ADDENDUM #2

REQUEST FOR QUOTATIONS (RFQ) NO.:	1220-040-2017-114
TITLE:	FLEETWOOD RECREATION CENTRE ROOF REPLACEMENT
ADDENDUM ISSUE DATE:	November 1, 2017
REVISED CLOSING DATE:	prefer to receive Quotations on or before: November 15, 2017

Figure 2.1.1.1:

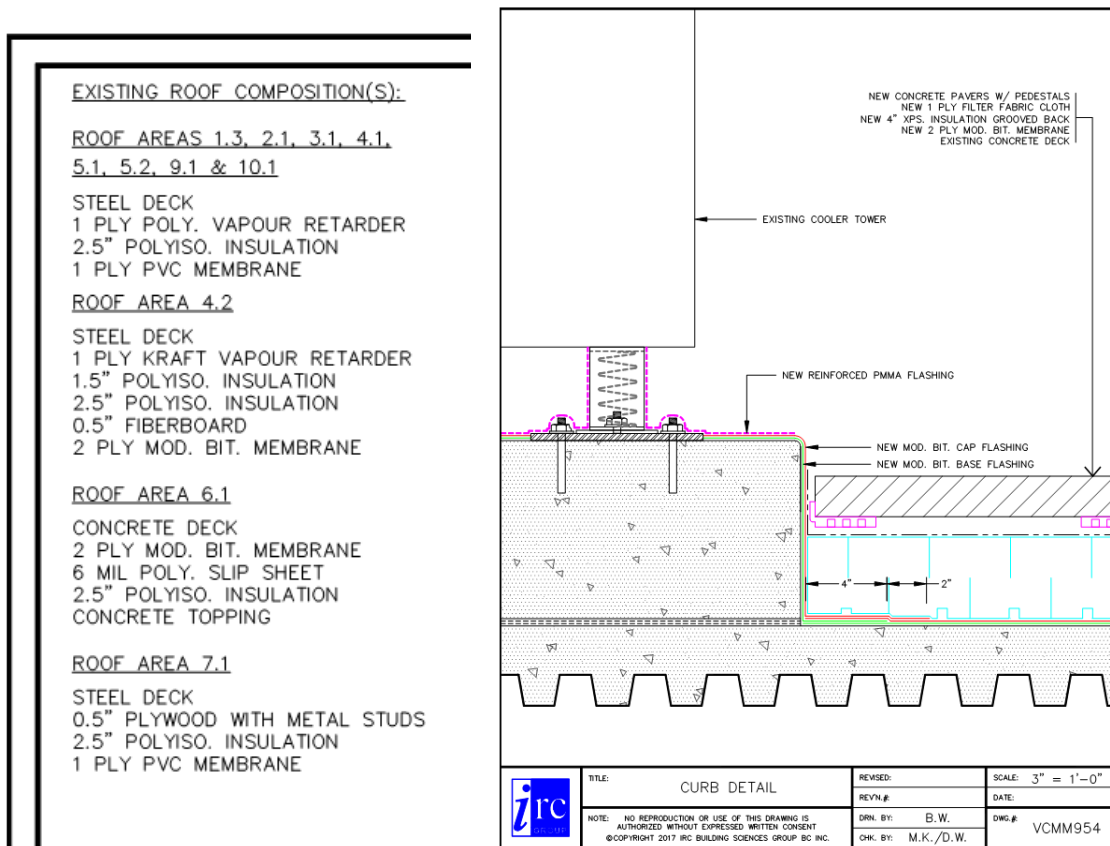
- 3) Provide and install three (3) new fall protection anchors on Roof Area 7.1 as per attached engineering documentation. See FP0, FP1, FP2 and VSMM851.
- 4) Add Separate Price SP-8 to Item 10 of Schedule C.
 - a) SP-8 is to provide a separate price to remove and reinstall Trespa cladding from vertical wall locations on Roof Areas 1.3, 3.1, 4.1, 5.1, and 7.1. See figure 2.2.1.1

below. Review figure 2.2.1.1 for image of defined area. Base bid shall not include for this work and shall be considered an addition to the contract. Re & Re is to facilitate installation of new SBS modified bitumen membrane as per RFQ documents.
